Access Compliance Report

Public Rights-of-Way

(Pedestrian Signals)

Intersection ID: N/A	Main Street:	Cross Street: N/A	Location: N/A
ADA ID: 83D181FC9A40	Signal Type: Two Push Buttons-Non APS	Overall Compliance: No	Severity Score: BTN 1:N/A BTN 2: N/A No BTN: N/A
Codes/Mitigation Info/Possible Solution		Field Measurements/Component Compliance

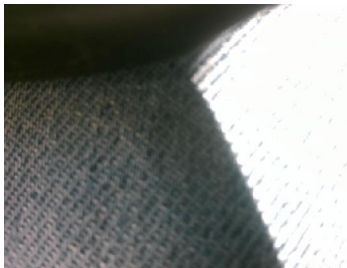
PROW/ADA: TMUTCD 4e.08, R404.2, R404.3, R406.2

Compliance	Description	Data	Compliance	Description	Data
	Button Count	Button2	N/A	Distant to Additional Button (in)	N/A
	Additional Button Present?	No		Additional Button ID	N/A
N/A	Signal Buttons Required?	N/A	N/A	Additional Ped Posts Required	N/A
	How Many Ped Street Xings?	2		Located In An Island/Median?	No
N/A	B 1 Sign Present?	Yes	N/A	B 2 Sign Present?	Yes
Yes	B 1 Sign Purpose?	Yes	Yes	B 2 Sign Purpose?	Yes
Yes	B 1 Sign Lettering & Contrast?	Yes	Yes	B 2 Sign Lettering & Contrast?	Yes
Yes	B 1 Parallel To XWalk?	Yes	Yes	B 2 Parallel To XWalk?	Yes
Yes	B 1 PAR to Button?	Yes	Yes	B 2 PAR to Button?	Yes
Yes	B 1 PAR to XWalk?	Yes	Yes	B 2 PAR to XWalk?	Yes
Yes	B 1 Clear Floor Space?	Yes	Yes	B 2 Clear Floor Space?	Yes
N/A	B 1 FWD Approach?	Yes	N/A	B 2 FWD Approach?	Yes
N/A	B 1 FWD Approach Constrained?	No	N/A	B 2 FWD Approach Constrained?	No
No	B 1 FWD Approach Reach (in)	6.0	No	B 2 FWD Approach Reach (in)	7.0

N/A	B 1 FWD Approach Width (in)	N/A	N/A	B 2 FWD Approach Width (in)	N/A
N/A	B 1 FWD Approach Obstruction?	Yes	N/A	B 2 FWD Approach Obstruction?	Yes
N/A	B 1 FWD Approach Obstruction Dist (in)	0.0	N/A	B 2 FWD Approach ObstructionDist (in)	4.0
N/A	B 1 PARA Approach?	Yes	N/A	B 2 PARA Approach?	Yes
N/A	B 1 PARA Approach Constrained?	No	N/A	B 2 PARA Approach Constrained?	No
Yes	B 1 PARA Approach Reach (in)	6.0	Yes	B 2 PARA Approach Reach (in)	7.0
N/A	B 1 PARA Approach Width (in)	N/A	N/A	B 2 PARA Approach Width (in)	N/A
N/A	B 1 PARA Approach Obstruction?	Yes	N/A	B 2 PARA Approach Obstruction?	Yes
N/A	B 1 PARA Approach Obstruction Dist (in)	0.0	N/A	B 2 PARA Approach ObstructionDist (in)	4.0
No	B 1 Clear Floor Space Slope (%)	2.8	No	B 2 Clear Floor Space Slope (%)	5.1
No	B 1 Clear Floor Space XSlope (%)	12.4	No	B 2 Clear Floor Space XSlope (%)	6.8
N/A	B 1 PAR Slope (%)	1.9	N/A	B 2 PAR Slope (%)	3.4
Yes	B 1 Height (in)	40.0	Yes	B 2 Height (in)	40.0

Yes	B 1 Clear Xing Direction?	ClearlyMarked	Yes	B 2 Clear Xing Direction?	ClearlyMarked
	B 1 Crossing Direction	To S		B 2 Crossing Direction	To E
No	B 1 DistanceTo XWalk (in)	61.0	Yes	B 2 DistanceTo XWalk (in)	0.0
No	B 1 DistanceTo Curb (in)	123.0	No	B 2 DistanceTo Curb (in)	109.0
Yes	B 1 Diameter (in)	2.0	Yes	B 2 Diameter (in)	2.0

Possible Solutions: Replace Signal Push Button With APS Button on New Post. Remove & Relocate Sign.
